**CASE COVER SHEET**

City of Rockwall  
Planning and Zoning Department  
385 S. Goliad Street  
Rockwall, Texas 75087

PROJECT: **NEW COMERCIAL**

PLAN: ELEVATIONS

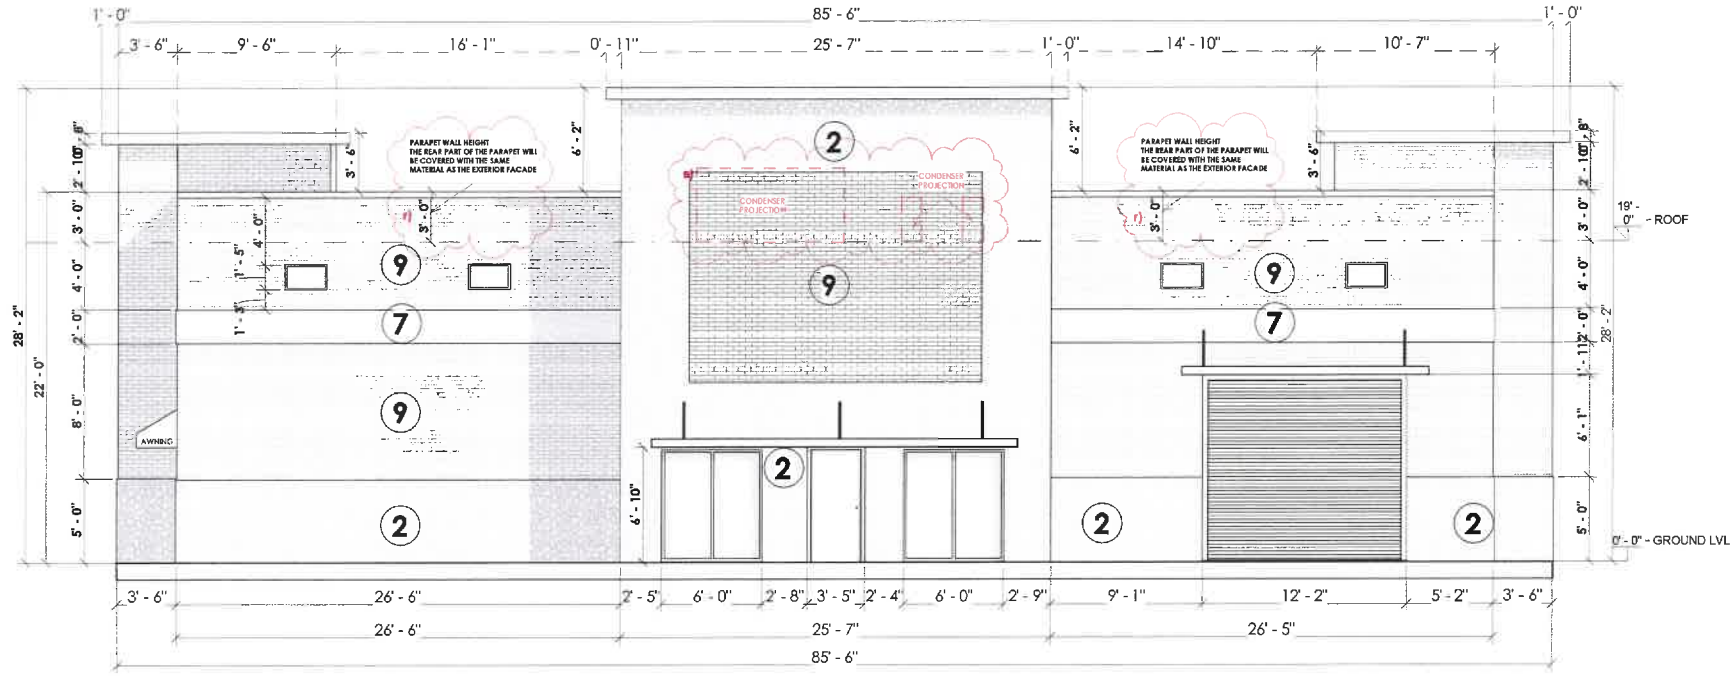
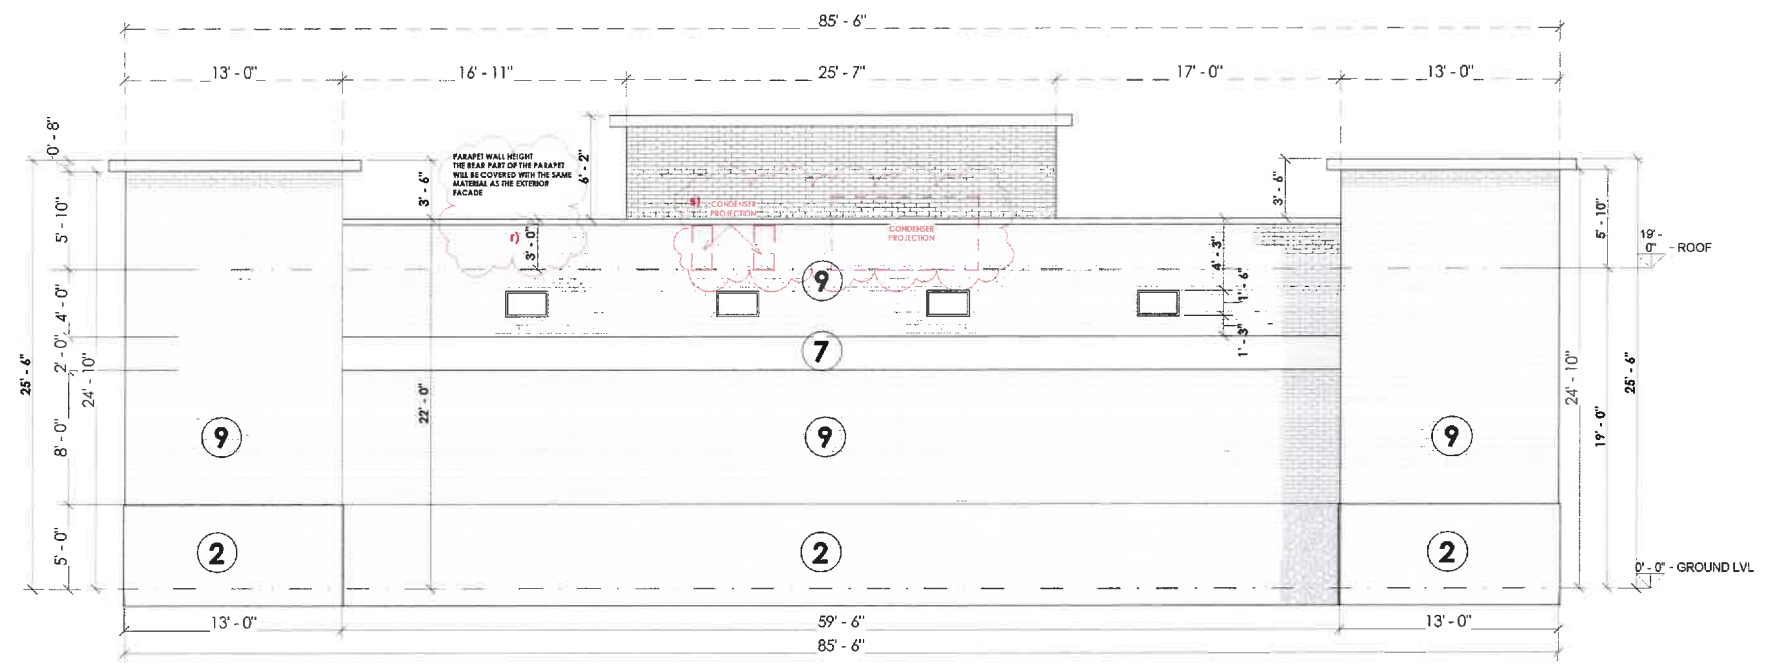
REV. NO.	DATE	COMMENTS
1	12/03/2024	a) Added case number b) Standard signature block with signature space for Planning and Zoning Chair and Planning Director attached c) The roof will be standing seam d) Parapet height noted and the rear part of the parapet will be covered with the same material as the exterior facade e) The bottom of RTUs is indicated

**FLOOR PLAN**

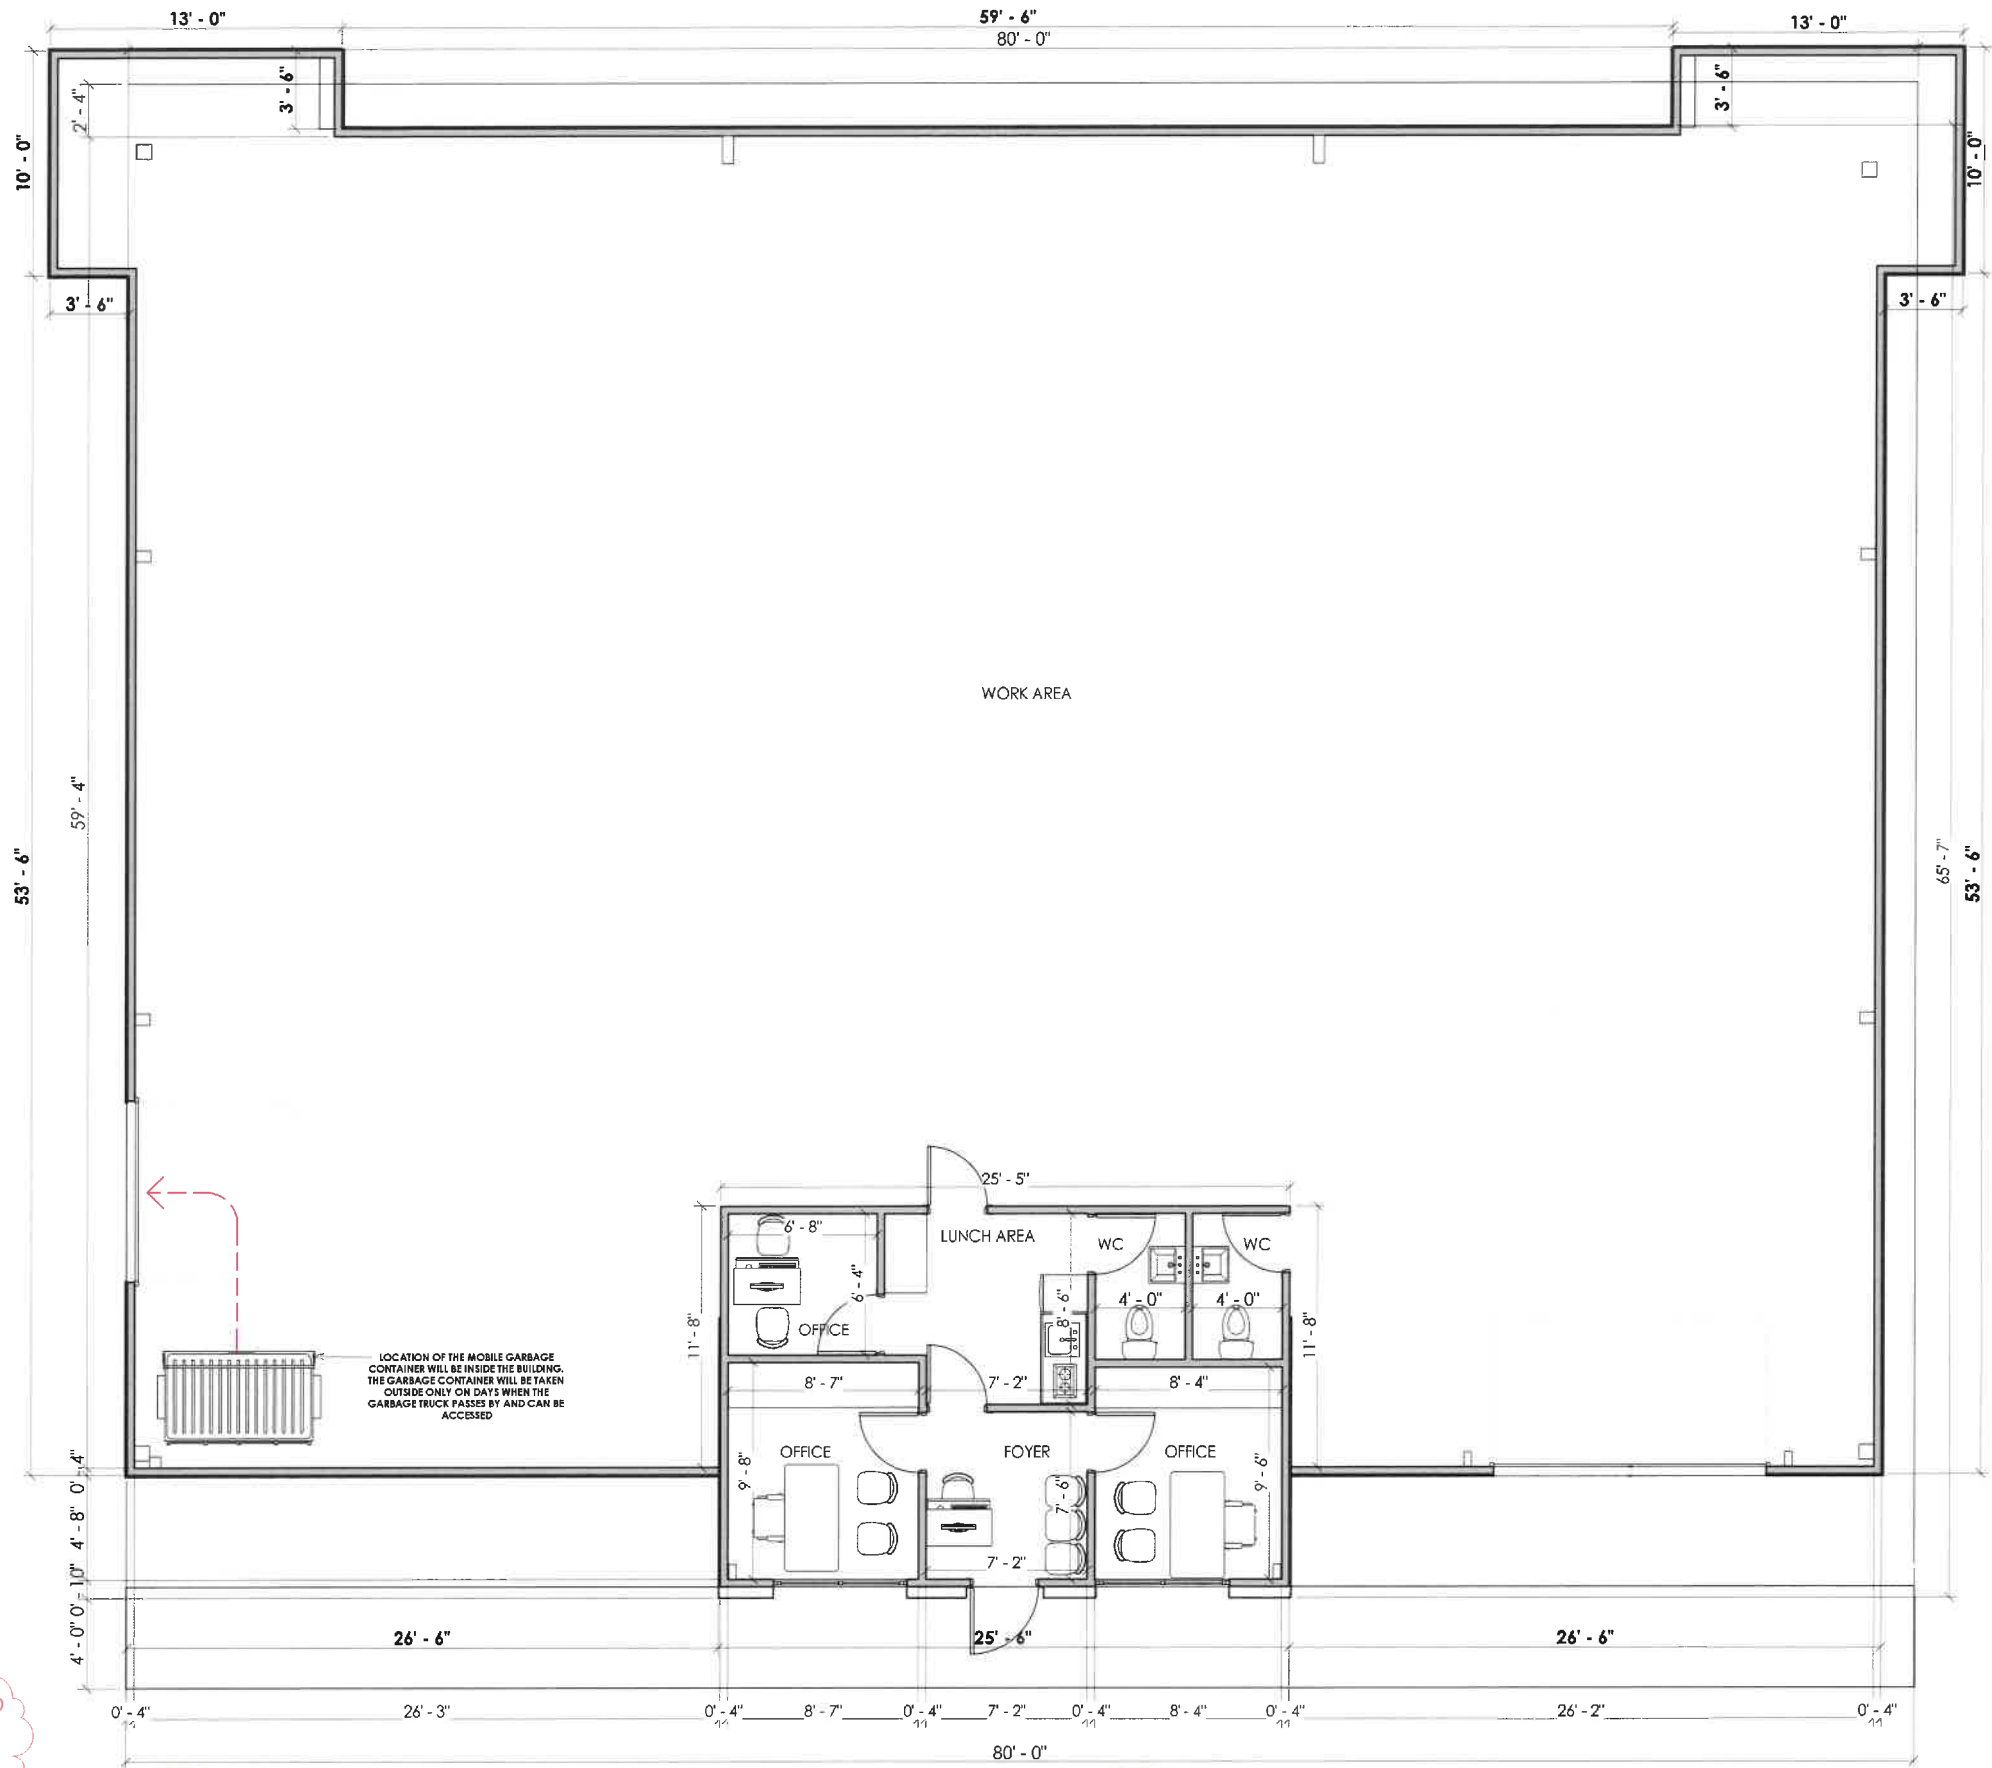
REV. NO.	DATE	COMMENTS
1	22/09/2024	a) added case number b) changed signature block with signature space for Planning and Zoning Clerk and Planning Director attached c) location of the Mobile Garbage Container will be inside the building. The garbage container will be taken outside only on days when the garbage truck passes by and can be accessed.
